SUMMARY OF CONCERNS IN RELATION TO THE PROPOSED NORTHCONNEX TUNNEL

This is an objection to many aspects of the proposed NorthConnex tunnel.

However, on careful reading of the NorthConnex Environmental Impact Statement (EIS), we have serious concerns with regard to the tunnel project as it is currently proposed in the EIS. Our concerns are detailed in six sections which show the changes we consider necessary to make the project acceptable.

MOTORWAY OPERATIONS COMPLEX - SOUTHERN VENTILATION FACILITY - SECTIONS
M1-M2-5000-DR-JD-0525

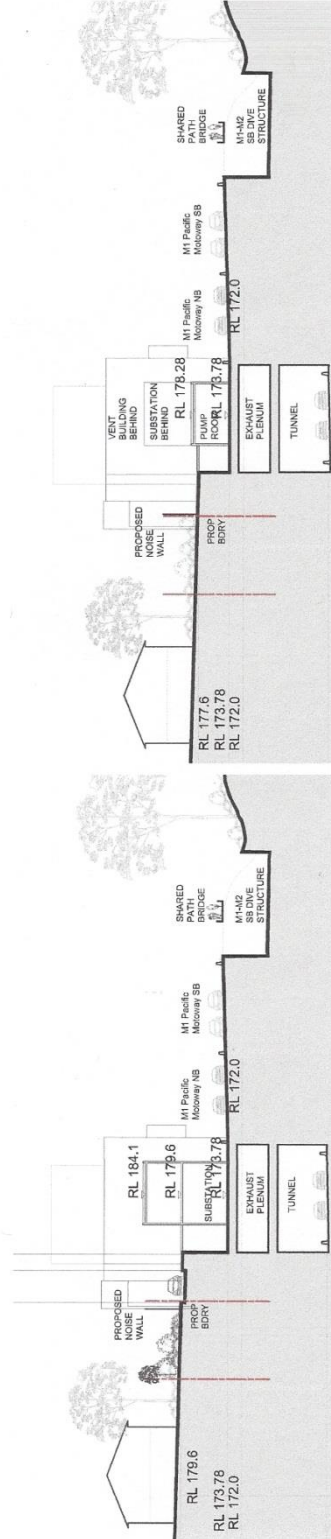
5. *EIS Volume 4, Technical working papers - Urban Design, 6.0 Operational Ancillary Facilities*
EIS Page 99 there is the diagram "Motorway Operations Complex – Southern Ventilation Facility – sections. *Page 10 below* The diagram has the cryptic label "Connection to tunnel TBC". What does TBC stand for? To be considered? Why is tunnel singular? Which tunnel is the diagram referring to northbound or southbound? There is no diagram showing any connection from the Southern Interchange ventilation facility to either the northbound or the southbound tunnel in any way AND YET

- Diagrams need to be provided showing the inter-relation between the shaft, the ventilation outlet and the motorway operations centre with a clear description of what is to be constructed and how it will operate.
- The community needs irrefutable evidence that the polluted air from the southbound tunnel exit portals will not be allowed to flow like an invisible sewer through West Pennant Hills, North Rocks, Carlingford and Beecroft.

MOTORWAY OPERATIONS COMPLEX - SOUTHERN VENTILATION FACILITY - SITE SECTION 1-1
M1-M2-5000-DR-UD-0713

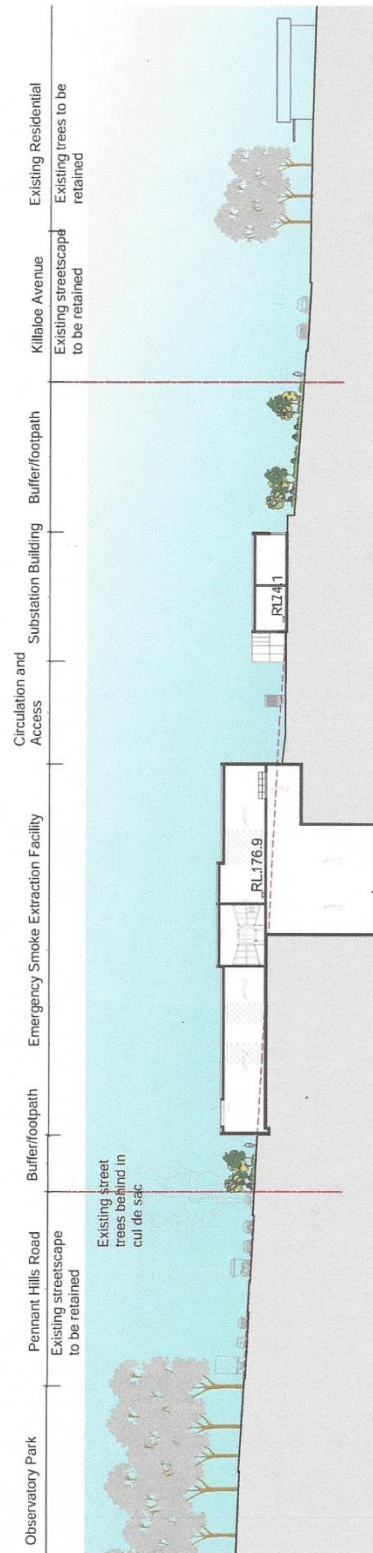
6. *EIS Volume 4, Technical working papers Urban Design, 8.0 Landscape Design*
EIS Page 176 is the diagram "Motorway Operations Complex – Southern Ventilation Facility – Site 1-1". *Page 13 below* The diagram does not show any connection to either the northbound or southbound tunnel. In the same Landscape Design section, EIS Page 182 is the diagram "Wilson Road Tunnel Support Facility –Section" *Page 14 below* which clearly shows the connection to the tunnels. In the same Landscape Design section, EIS Page 189 is the diagram "Northern Ventilation Facility – Landscape Concept Section". *Page 15 below* This also clearly shows the connection to the tunnels.
